TECHNICAL BULLETIN

[Issue No.] GOT-A-0055

[Title] Backlight model name errors indicated on GT1575-STB□ rating plate

[Relevant Models] GOT1000 Series (GT15 model : GT1575-STBA, GT1575-STBD)

■ Indication of the rating plate (GOT rear face)

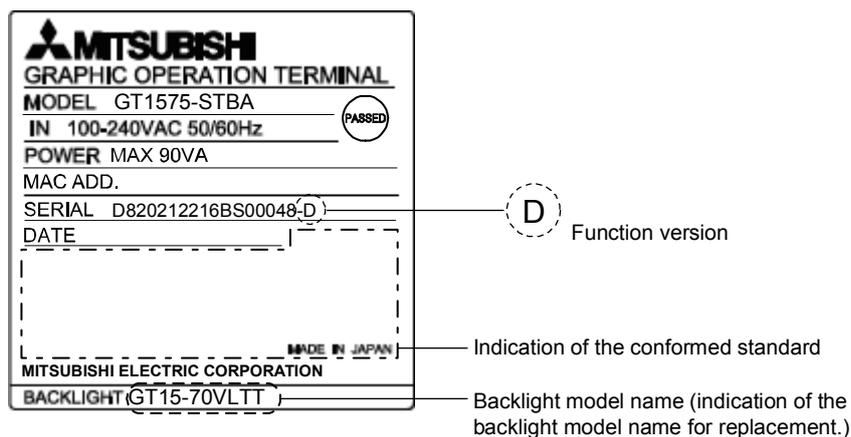
On the rating plate of the GOT whose backlight is replaceable, the corresponding backlight model name is indicated. When the display appearance of LCD was improved in December 2006, the backlight model name was changed in accordance with LCD change.

The old backlight model name was incorrectly indicated on the target GOTs whose production period was written in the following chapter 3.

Please confirm the function version before purchasing or using the backlights for replacement.

■ Packaging box

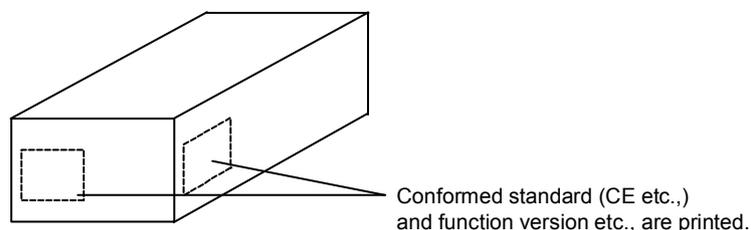
Confirm the function version on the label of the GOT packaging box.
The label position varies depending on the models or shipment time.
